BID ADDENDUM NO. 4

Date of Addendum: April 17, 2026
Issued for Bid Date: March 27, 2026
Client Name: Public Schools of the Tarrytowns
Project Name: 2024 Capital Bond Project – Phase 2; Washington Irving Intermediate School
SED Project No.: 66-04-01-03-0-002-017
TUFSD Bid Number: 25/26-TUFSD-003
MEMASI Project No.: 101-2403
Contracts: Contract 1: General Construction (GC)
Contract 2: Mechanical Construction (MC)
Contract 3: Electrical Construction (EC)
Contract 4: Plumbing Construction (PC)

20

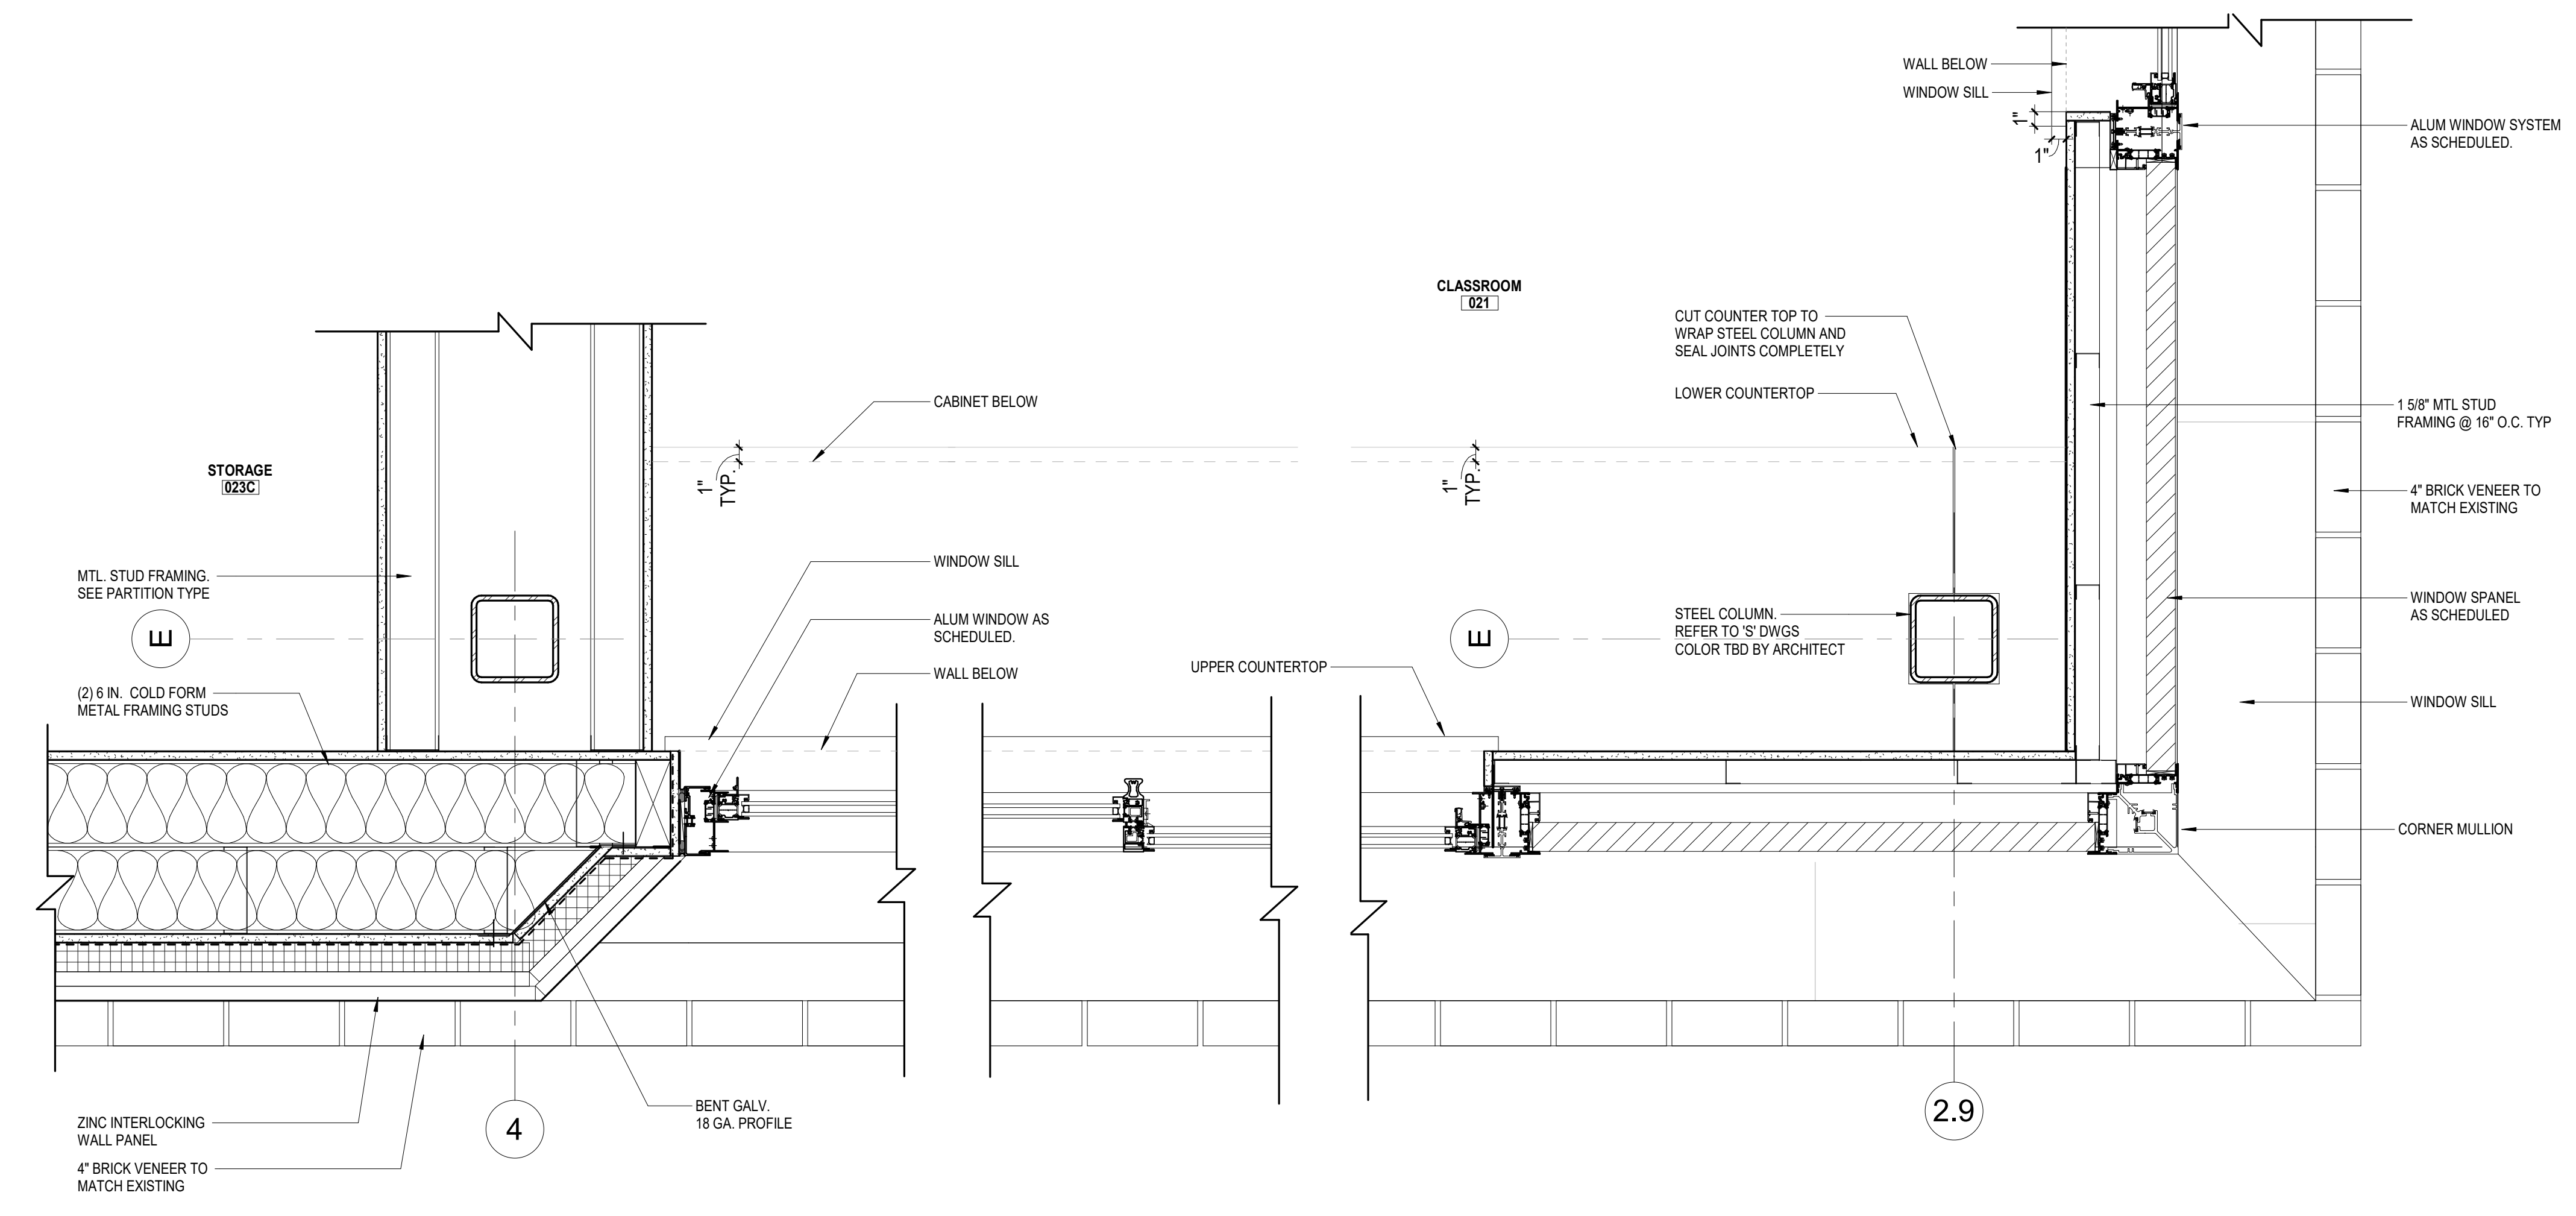
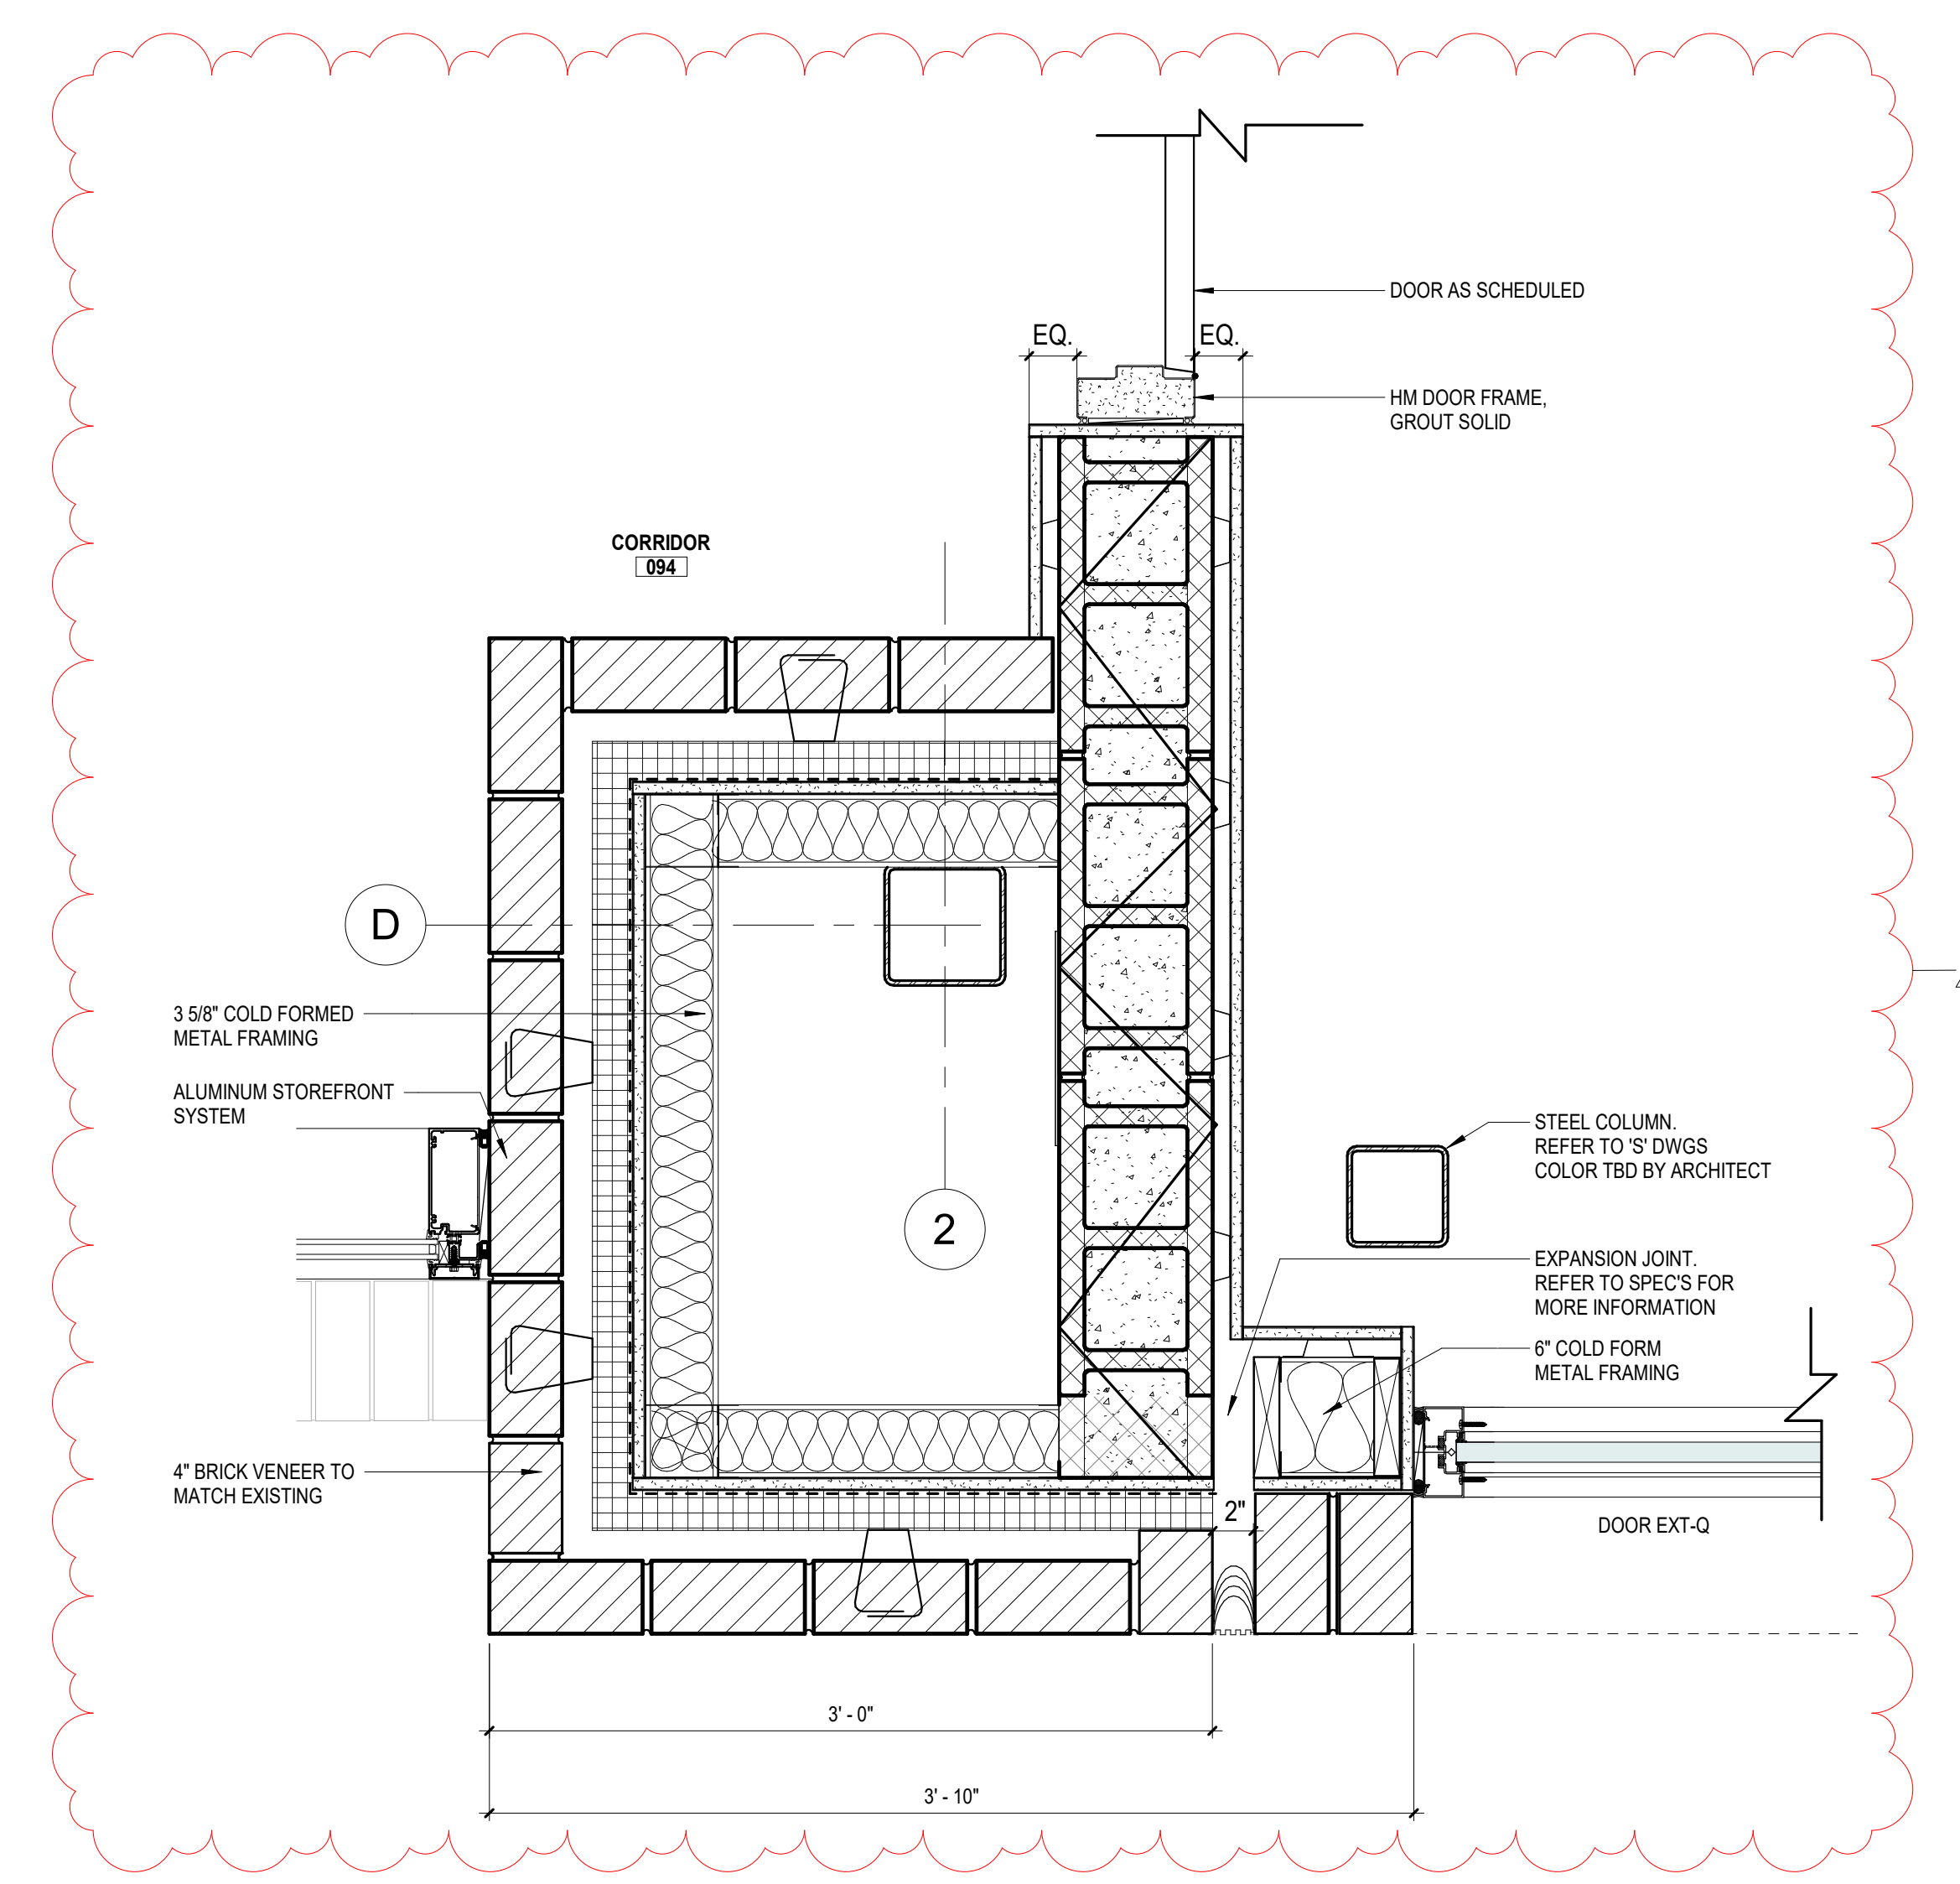
- h. SHEET A502 – PLAN DETAILS; DELETE existing Details 10/A502 and 20/A502 on sheet A502, dated 03/27/2026; ADD Details 10/A502 and 20/A502 on sheet A502, revised 04/17/2026, attached.

STEEL BEAM LEGEND

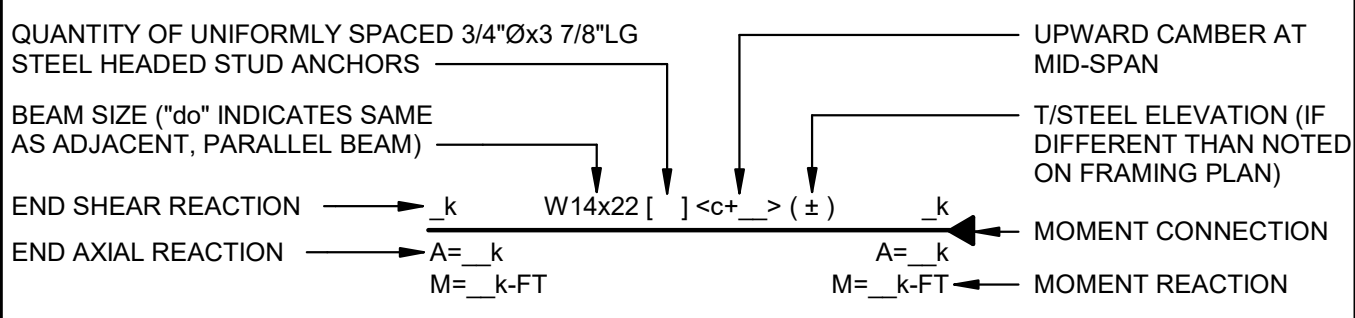
- i. SHEET A904 – SIGNAGE SCHEDULE; DELETE sheet A904 in its entirety.
- j. SHEET S002 – GENERAL NOTES CONTINUED – REVISE existing ‘STEEL BEAM LEGEND’, with revisions as shown on the attached sketch. Revised 4/17/2026, attached.

10 SECTION
S200 NOT TO SCALE

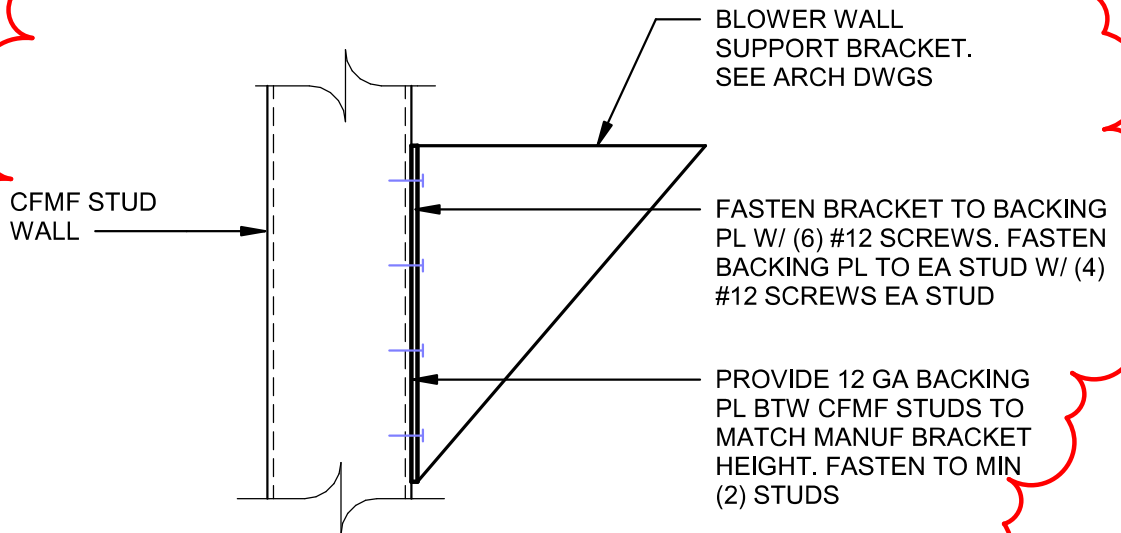
- o. SHEET S200 – PARTIAL PLANS AND DETAILS – REVISE existing detail 10/S200 with revisions shown on the attached sketches. Revised 4/17/2026, attached.

11 PARTIAL PLAN AT GYMNASIUM BLEACHER

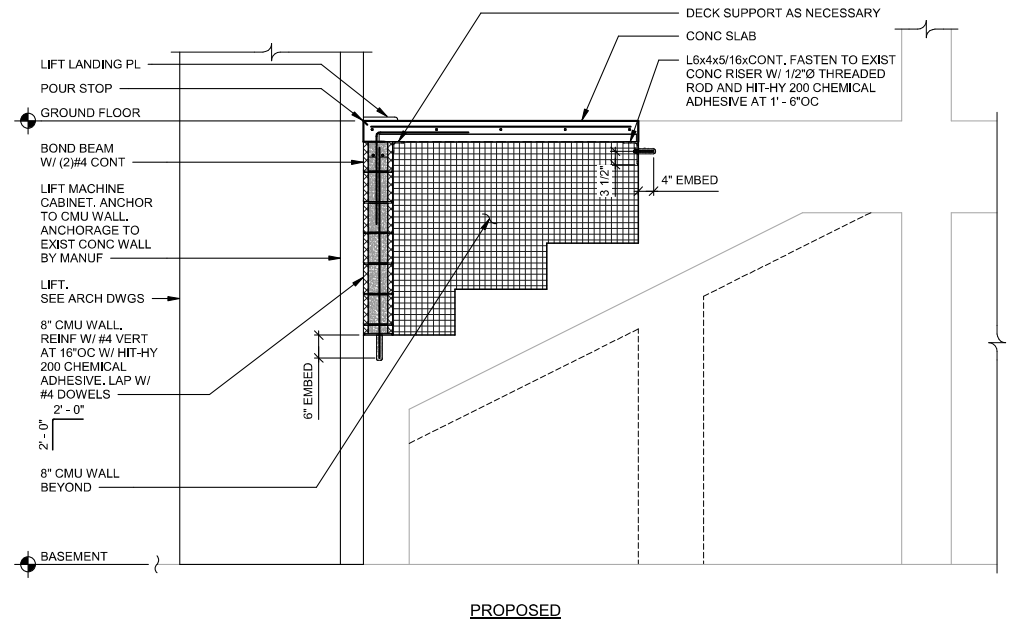
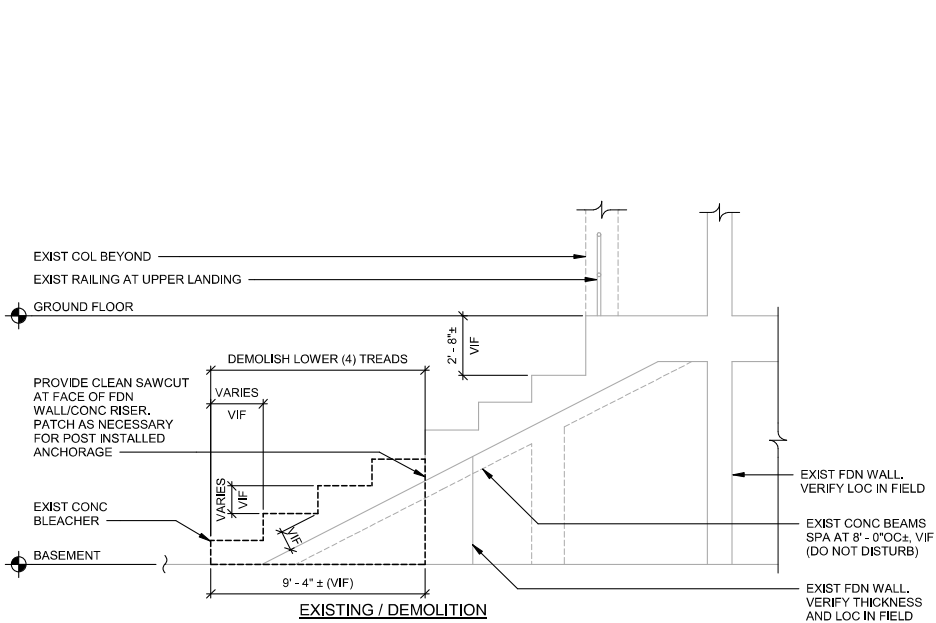
- p. SHEET S200 – PARTIAL PLANS AND DETAILS – REVISE existing detail 11/S200 with revisions shown on the attached sketches. Revised 4/17/2026, attached.

SECTION 12
S200 SCALE: 1/4" = 1'-0"

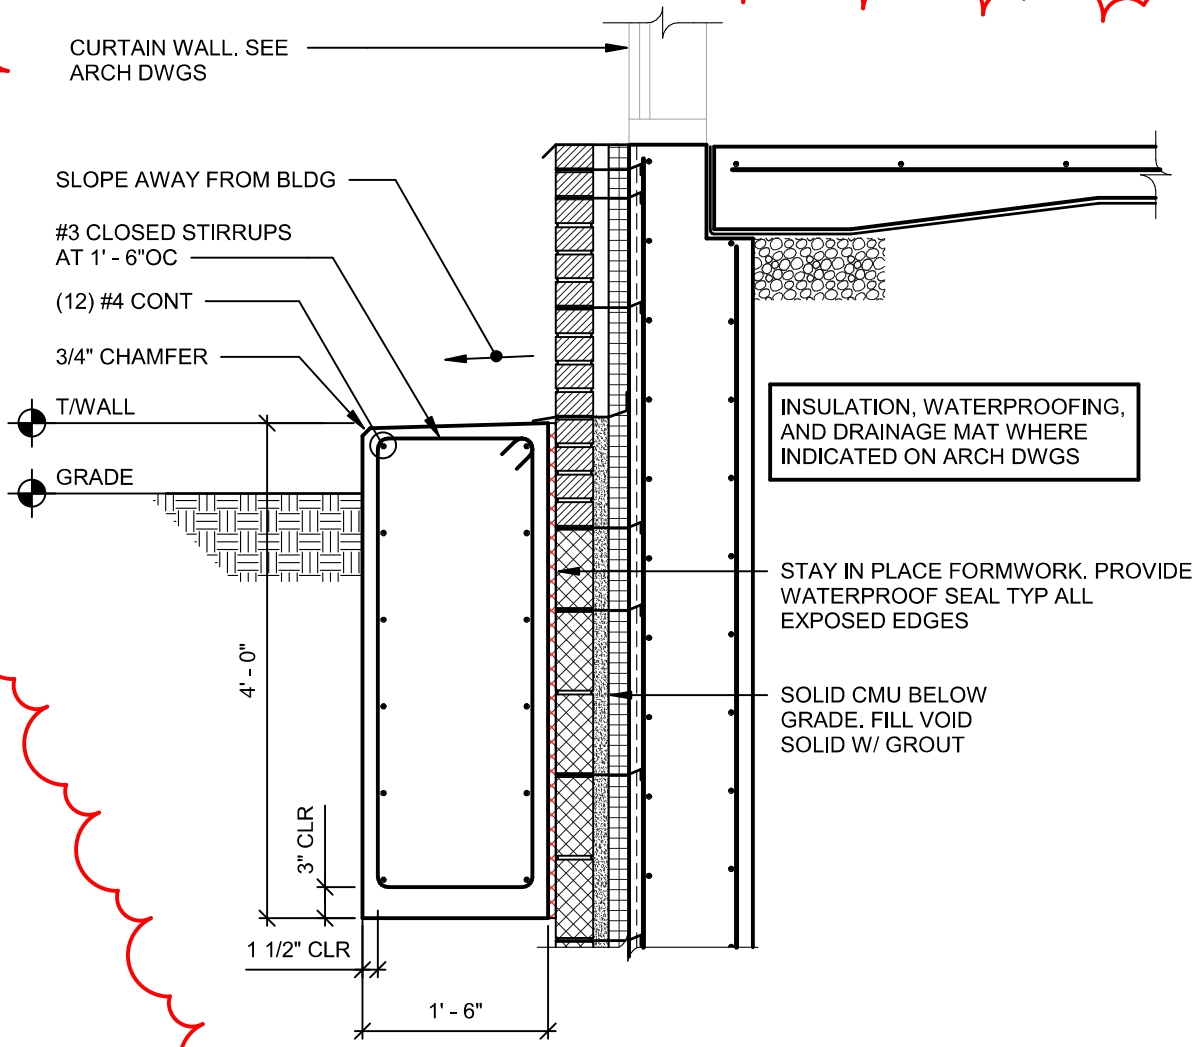
- q. SHEET S200 – PARTIAL PLANS AND DETAILS – ADD detail 12/S200 to existing sheet S200 with revisions shown on the attached sketches. Revised 4/17/2026, attached.
